NOV_SCE ATJ_20220406-01

NOTICE OF VIOLATION

Energy Safety Inspection Report

Report Name: SCE_ATJ_20220406-01

Structure ID: 4237077E

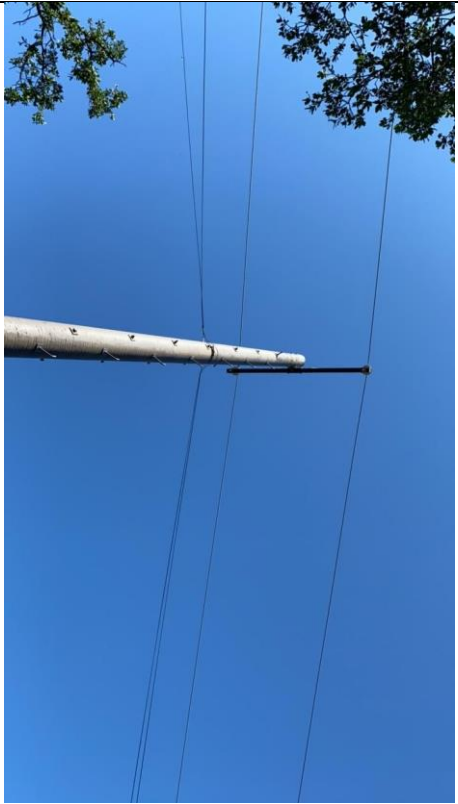
| Item | Structure ID | HFTD | Initiative Number | Violation Type | Severity | Violation Description |
|------|--------------|----------|-------------------|-----------------------|----------|---|
| 1 | 4237077E | Non-HFTD | 7.3.3.3.1 | Adherence to Protocol | Minor | Failure to install vibration dampers on a span |

Item1IA1img1: No vibration dampers

Structure ID: 4362869E

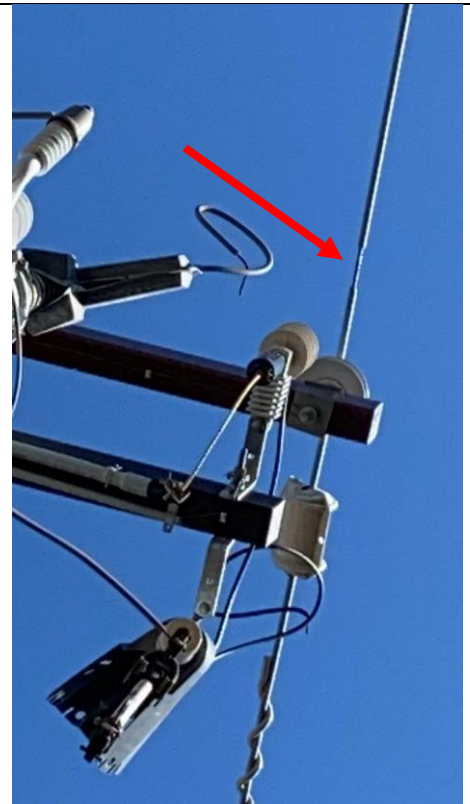
partially covered exposed conductor." Energy Safety observed structure numbered 4362869E that showed a pothead cover on the ground next to the structure with an uncovered splice on one phase of covered conductor. Energy Safety considers this violation for failure of adhering to protocol to be in the Minor risk category.

Item3IA1Img1: Wildlife terminator/pothead on ground next to pole

Item3IA1Img2: No Wildlife terminator/pothead on conductor, exposing conductor

Item3IA1Img3: Observation, 3 Fuses are popped with jumpers hanging in air

Structure ID: 4237080E

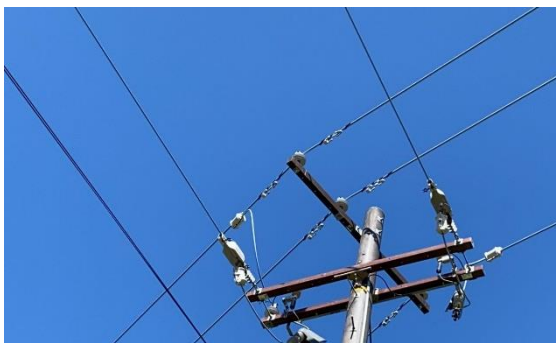
| Item | Structure ID | HFTD | Initiative Number | Violation Type | Severity | Violation Description |
|------|--------------|----------|-------------------|-----------------------|----------|---|
| 3 | 4237080E | Tier 2 | 7.3.3.3.1 | Adherence to Protocol | Minor | Failure to install vibration dampers on a span |

Item4IA1Img1: No Vibration dampers on secondary phase level

Structure ID: 4477345E

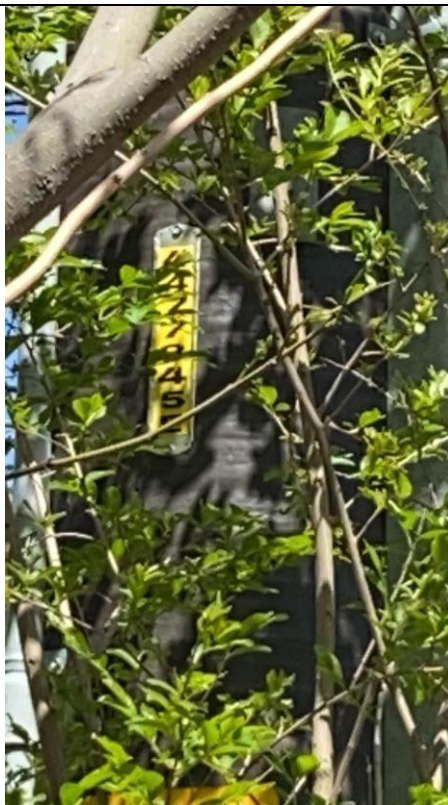
| Item | Structure ID | HFTD | Initiative Number | Violation Type | Severity | Violation Description |
|------|--------------|----------|-------------------|-----------------------|----------|---|
| 4 | 4477345E | Tier 2 | 7.3.3.3.1 | Adherence to Protocol | Minor | Failure to install vibration dampers on a span |

Item6IA1Img1: No vibration dampers

Initiative Activity #2 Photo

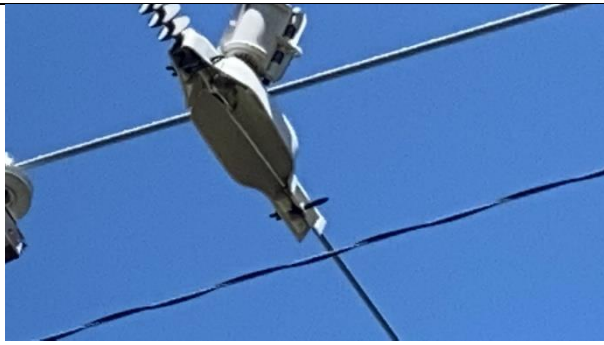
3. Violation 3: Per SCE's DOH, Table DC 535-1: Wildlife Protection Material, SCE requires that anti-rotation clips be used with Dead-End Clamp Covers.¹ Pole numbered 4477345E and 4465129E did not have anti-rotational clips installed in dead-end covers. Energy Safety considers this violation for failure of adhering to protocol to be in the Minor risk category.

| Item | Structure ID | HFTD | Initiative Number | Violation Type | Severity | Violation Description |
|------|--------------|----------|-------------------|-----------------------|----------|---|
| 5 | 4477345E | Tier 2 | 7.3.3.3.1 | Adherence to Protocol | Minor | Failure to install anti-rotational clip on dead end cover |

Item6IA2Img1: No anti-rotation clip installed on dead end cover
